Rasp Mine

Zinc–Lead–Silver Project

Response to Submissions Report

Project Application No. 07_0018

Figure 2-2: Operation Scenario 4 (Project Increment) – Maximum Predicted 24 Hour Average PM_{10} Concentrations ($\mu g/m^3$) Criterion = $50\mu g/m^3$

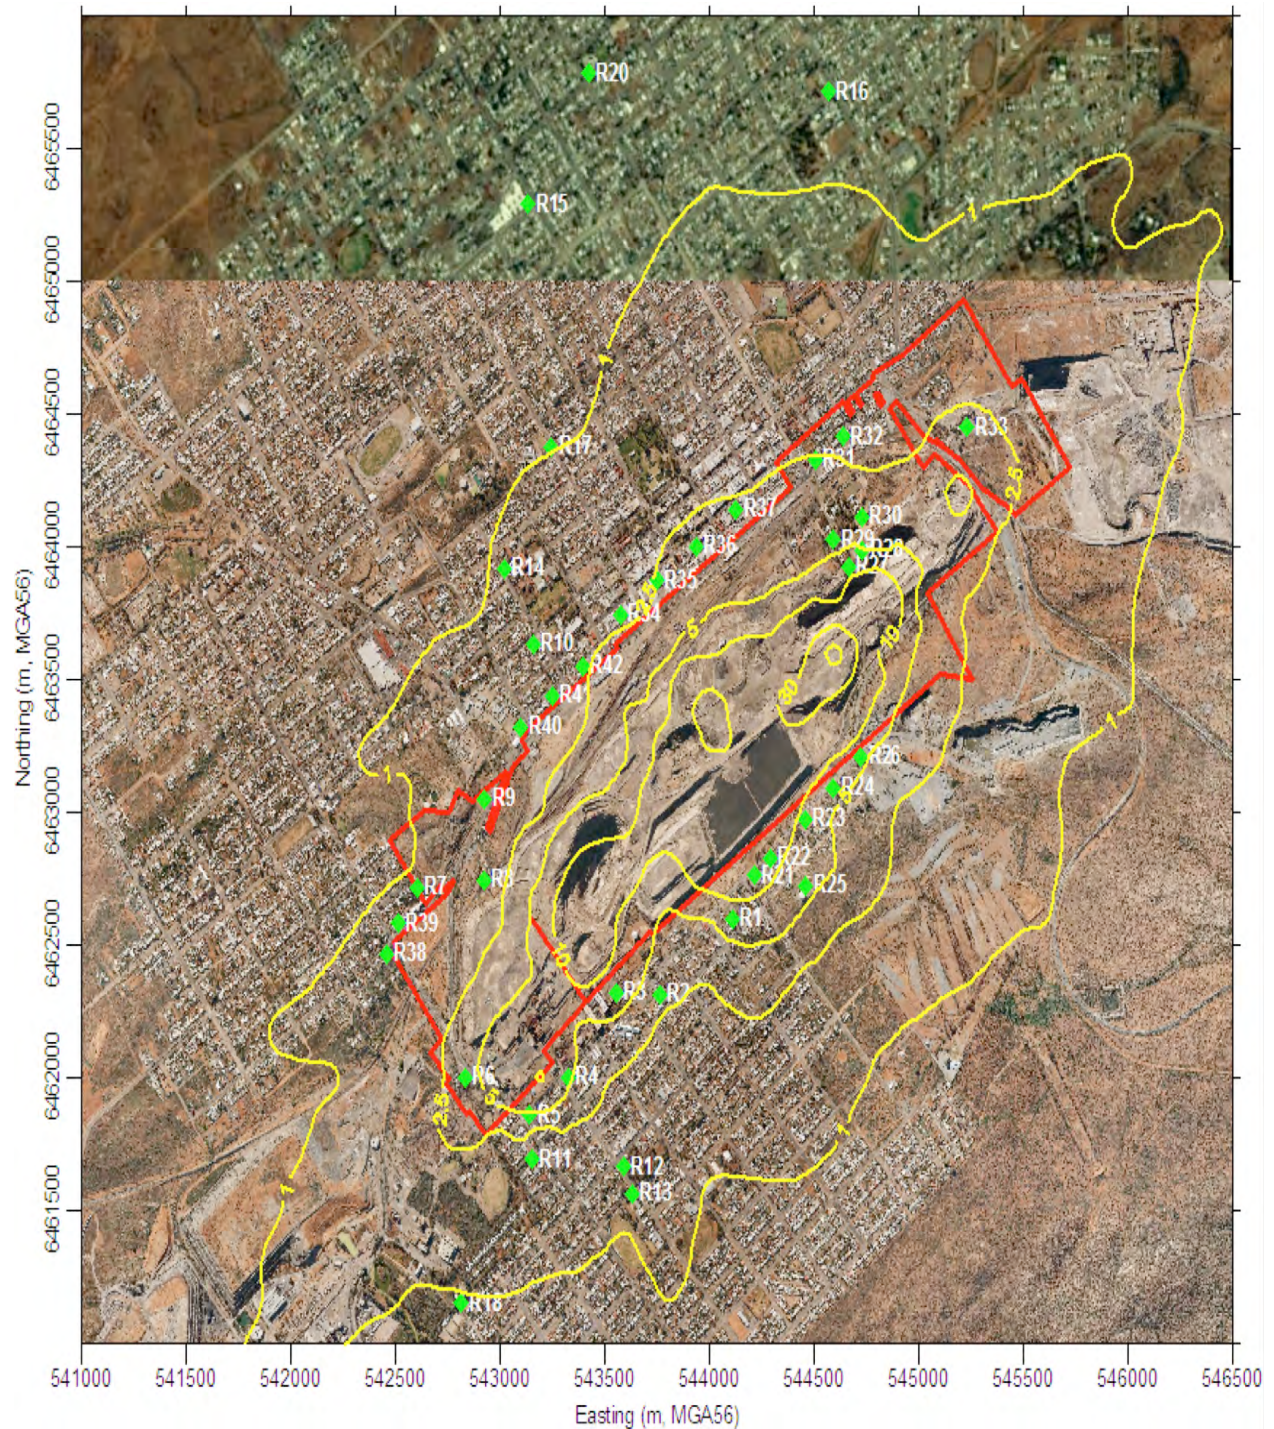
“At the meeting I agreed to provide further advice regarding the requirement of additional modelling assessment of the tailings storage facility. Based on the information provided, DECCW requests:

ENVIRON conducted the additional modelling on this basis. The modeling inputs and results are included in the *Air Quality Assessment Addendum* (ENVIRON, 2010) attached to the PPR, and are shown spatially as contours on **Figure 2-2**.

Modelling indicates that only those receptors in close proximity to the TSF1, specifically R1 and R21-R24 along the southeast boundary, show a noticeable influence due to the variation between normal and upset operations of the TSF1.

In all instances, and under the highly conservative assumption that any ‘Upset’ persists for up to 24-hours, DECCW air quality criteria are anticipated to be satisfied, even at receptors closest to the proposed TSF1. Maximum incremental predictions occur at Receptor R21, as a Project-related 24-hour increment of $11.8\mu\text{g}/\text{m}^3$.

Figure 2-3: Project-related “Free Areas”

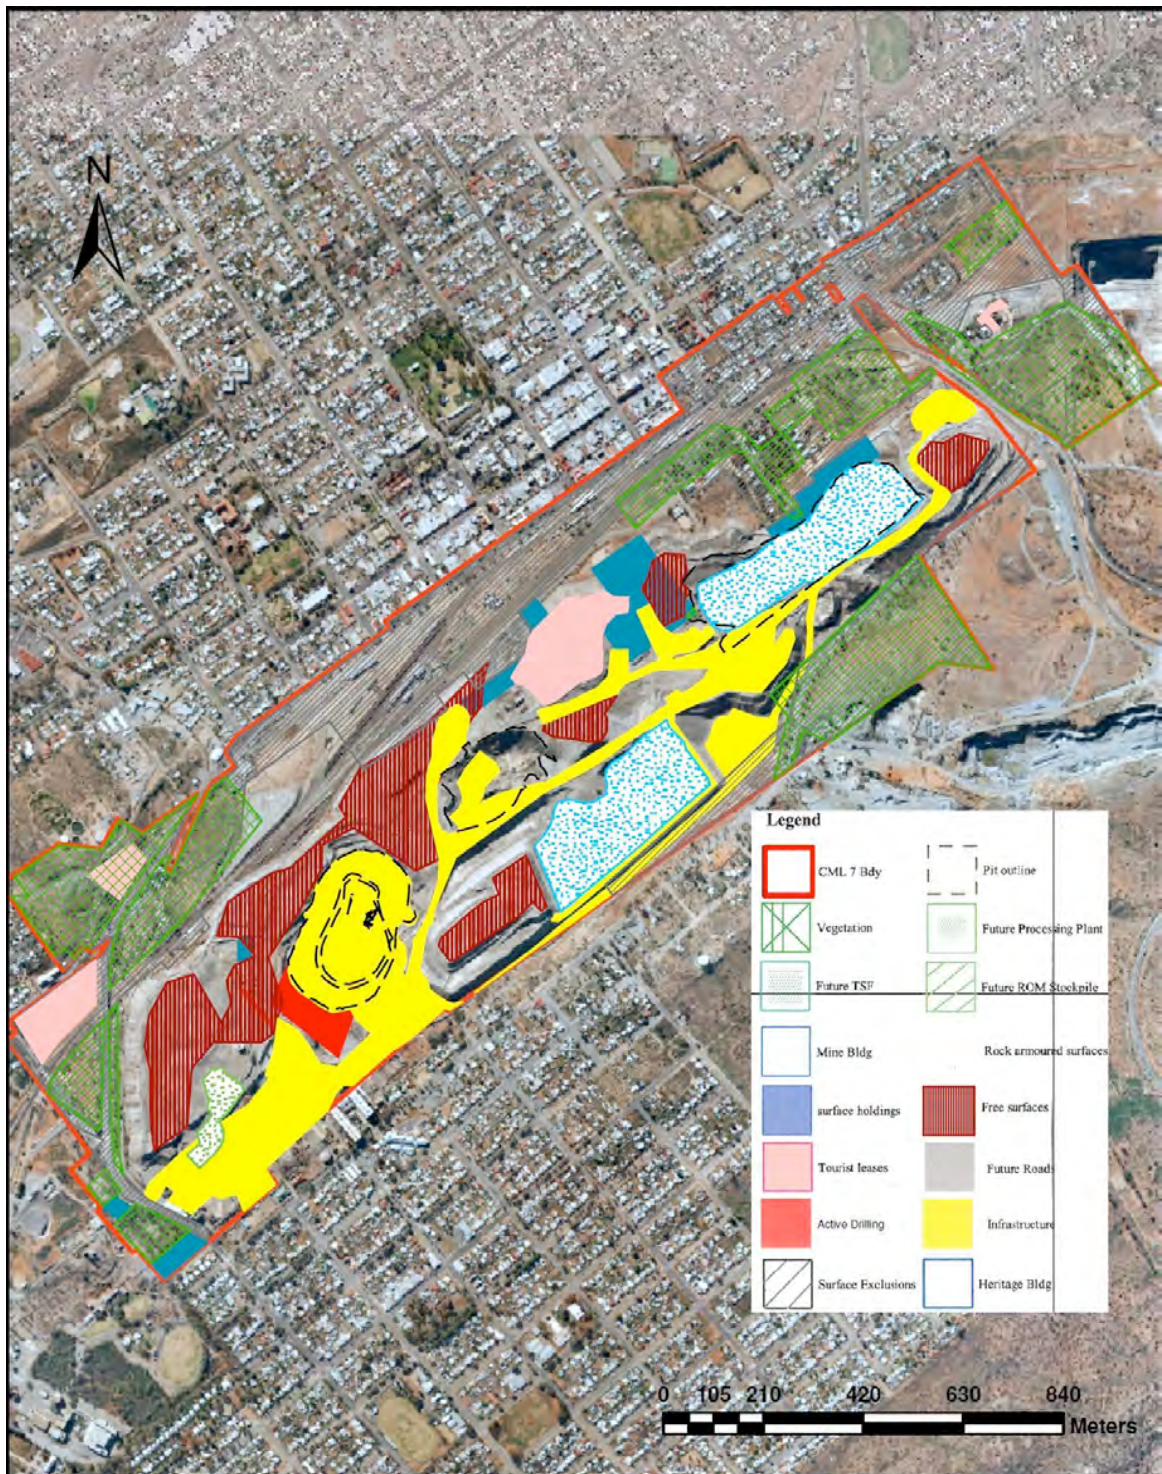
- **The commitment to “maintaining a surface crust to minimise potential wind erosion”. This should be revised to “chemical dust suppressants as per the manufacturer’s specifications, or more often as required, are to be used on all areas of the site potentially impacted by wind erosion”.**

The modelling undertaken as part of the *Air Quality Assessment Report* (ENVIRON, 2010) (Appendix H of EAR) was based on application of dust suppressants to all “free areas”. “Free areas” are defined as existing on-site areas which are exposed and which will not be impacted by the day-to-day operation of the mine. The location of all Project-related “free areas” are shown on **Figure 2-3**. To avoid confusion, BHOP proposes to add a reference to this figure in the SoC.

Chemical dust suppressants as per the manufacturer’s specifications, or more often as required, will be used on all areas of the site potentially impacted by wind erosion as per the ‘free areas’ marked on the following Figure.
